AEP-NRC-2021-43
10 CFR 50.55a

Donald C. Cook Nuclear Plant Units 1 and 2
Response to Request for Additional Information Regarding Relief Request for
Limited Coverage Examinations Performed In
The Fourth 10-Year Inspection Interval

Response to Request for Additional Information Regarding a Relief Request for Limited Coverage Examinations Performed in the Fourth 10-Year Inspection Interval

Figure 1: Layout of the BMI Tube Penetrations

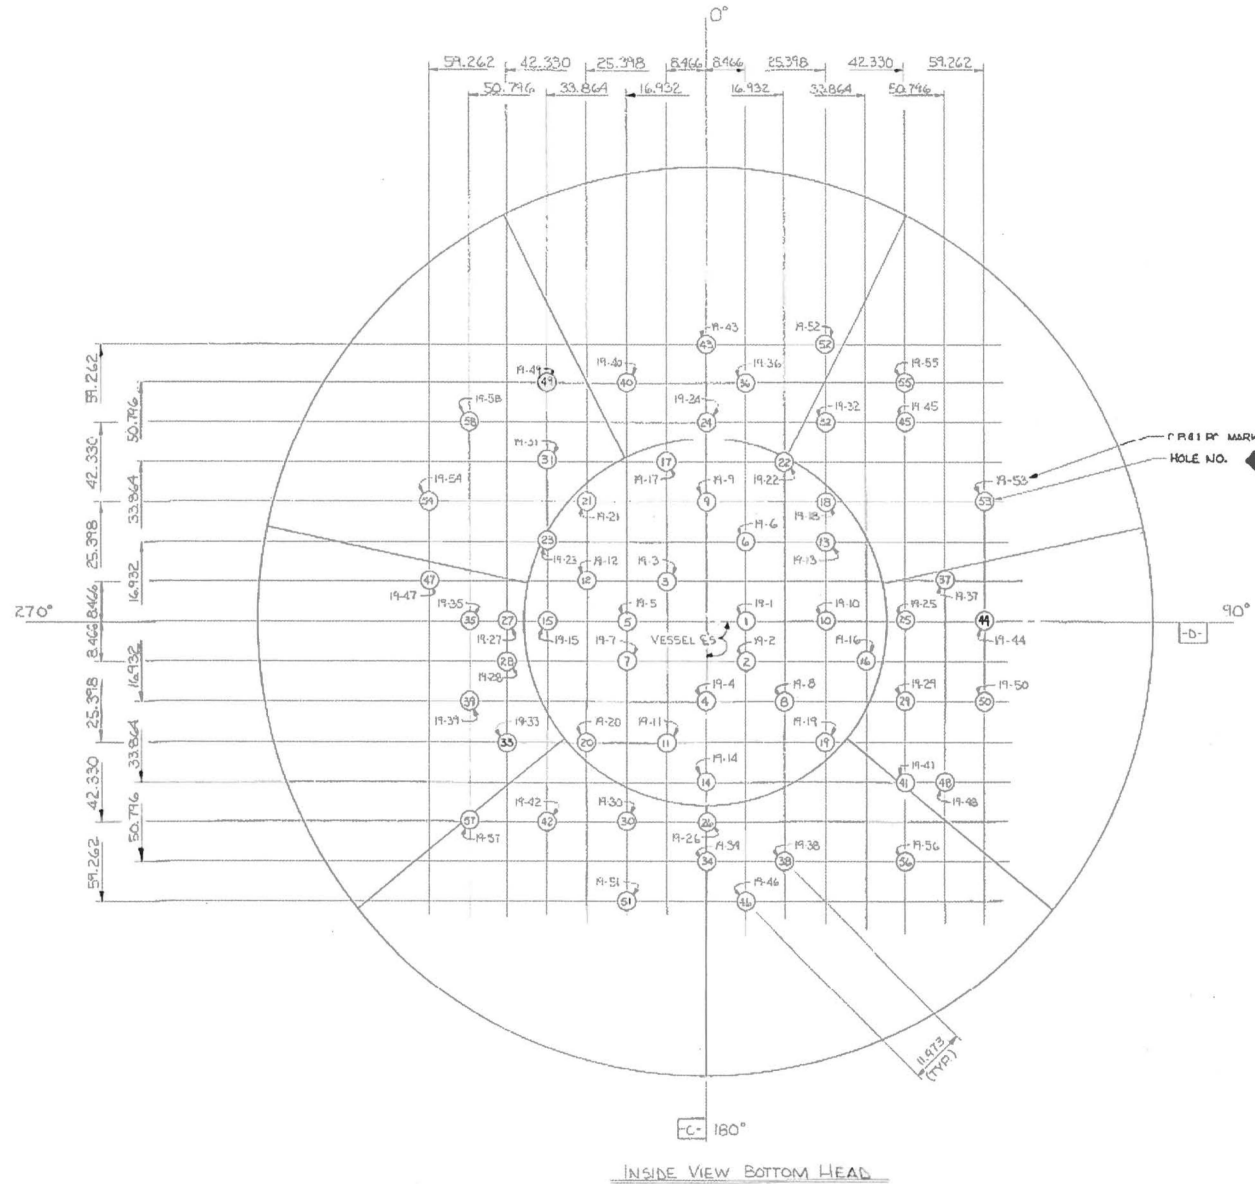
"Attachment 1 to Relief Request ISIR-4-11 states that for the reactor pressure vessel (RPV) lower head dollar plate weld, 2-RPV-E (2-LHC-01), the licensee achieved an examination coverage of 47.61%. The licensee stated that the limited examination coverage was caused by the bottom mounted instrumentation tubes as shown in Figures 1.27-2 and 1.27-3. The licensee detected an indication in the weld during the inspection performed in 2019.

- a. Discuss how the bottom mounted instrument tubes obstructed the examination coverage of the subject weld.*
- b. Discuss any efforts taken to increase the examination coverage. If no efforts were taken, please provide justification for the non-action."*

The bottom mounted instrumentation (BMI) tubes obstructed the examination coverage for the reactor pressure vessel (RPV) lower head dollar plate weld, 2-RPV-E (2-LHC-01), henceforth referred to as the subject weld, by either creating spaces too small to provide sufficient access for the robot performing the examination or by being located and configured such that the robot could be damaged in some way.

A total of 58 BMI tubes penetrate the RPV lower head. Some of these BMI tubes are adjacent to the subject weld. A diagram excerpted from drawing DC-03137 provided in Figure 1 below shows the layout of the BMI tubes in relation to the subject weld:

Per drawing DC-03135, each BMI tube is approximately 1.50" in diameter with a collar located 6" from the inside RPV end making each BMI tube 1.75" at its widest point. Per drawing DC-03136, there is a quarter-inch throat fillet weld around the inside vessel penetration point of each BMI tube. This gives a footprint of approximately 2.00" for each BMI tube at the penetration. Per drawing DC-03136, the BMI tubes have a vertical height of approximately 12" above the inside of the bottom of the RPV.

The clearance needed for the examination sled to scan the subject weld is limited by the footprint of the BMI tubes. As seen in Figure 1, each square is 8.5", and there are 17 BMI tubes located within approximately 6" of the subject weld. Those BMI tubes limit the sled from scanning all or part of the adjacent portion of the subject weld. Additionally, there are 12 more BMI tubes that are located within approximately 12" of the subject weld. All of these BMI tubes either prevented scanning or reduced the scanning area in both the parallel and perpendicular direction adjacent to the associated BMI tubes.

The vertical component of the BMI tubes also limits the positioning options of the arm, end effector and examination sled when scanning the subject weld. The arm must be maneuvered so as to avoid damaging tooling or potentially snagging the cables. The vertical component of BMI tubes radially in line with the arm also limits the examination sled access to portions of the subject weld located on the far side of the BMI tubes.

- b. Prior to performing the examination, the inspection vendor provided an examination coverage estimate for the subject weld accounting for BMI tube interference limitations of approximately 37 percent (%). As provided in Request for Relief ISIR-4-11, the actual achieved examination coverage was 47.61%. This additional examination coverage is attributed to the following efforts taken to increase the examination coverage:
